**OMAR N. BRADLEY AIRPORT (MBY)  
CITY OF MOBERLY, MISSOURI**

**MoDOT Project No. 19-034A-1**

**ADDENDUM NO. 1**

**June 1, 2020**

SAFETY DRAWING  
PHASE 1

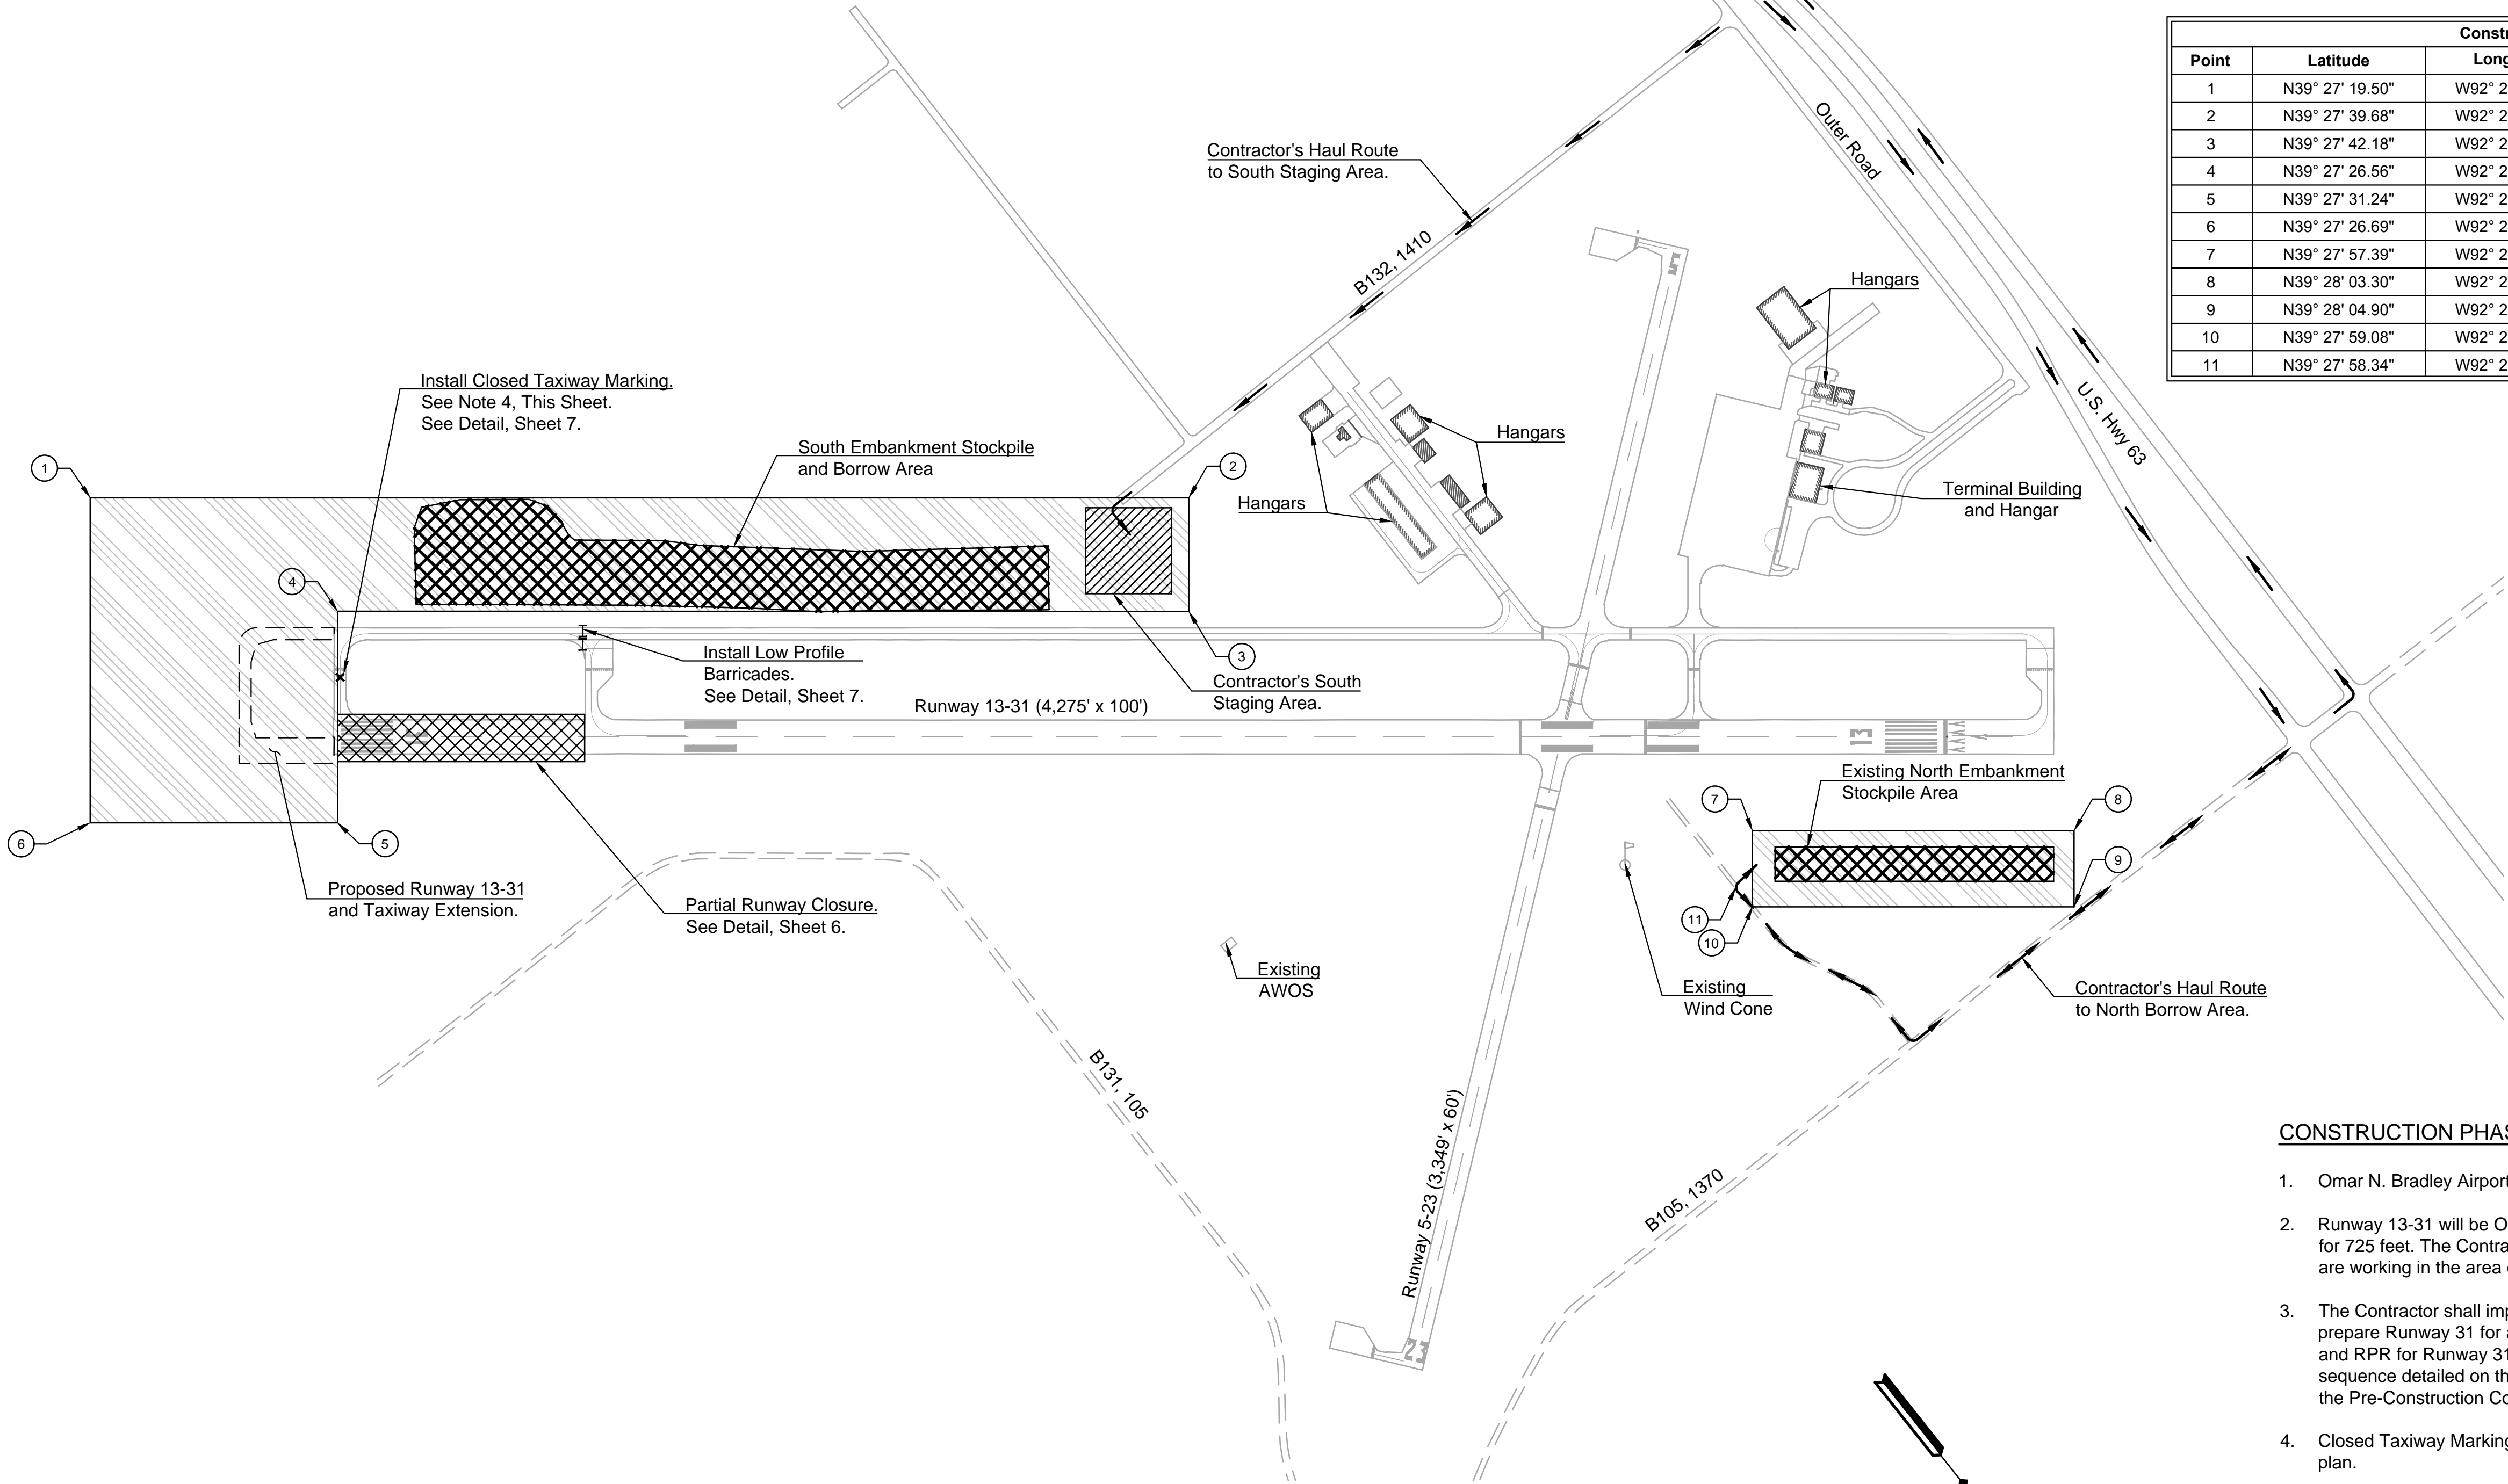
1. Sheet No. 3 Safety Drawing Phase 1. The scope of work listed in bullet point No. 5 has been changed to add in that the Contractor can complete Runway Safety Area (RSA) grading and compaction up to Station 30+00 during Phase 1.

- Closed Taxiway Markings and Low Profile Barricades will be placed as shown on this plan.
- The following construction work shall be completed:
  - Complete all grading and compaction and installation of drainage structures for the Parallel Taxiway Extension and Connecting Taxiway to Proposed Runway 31 Threshold.
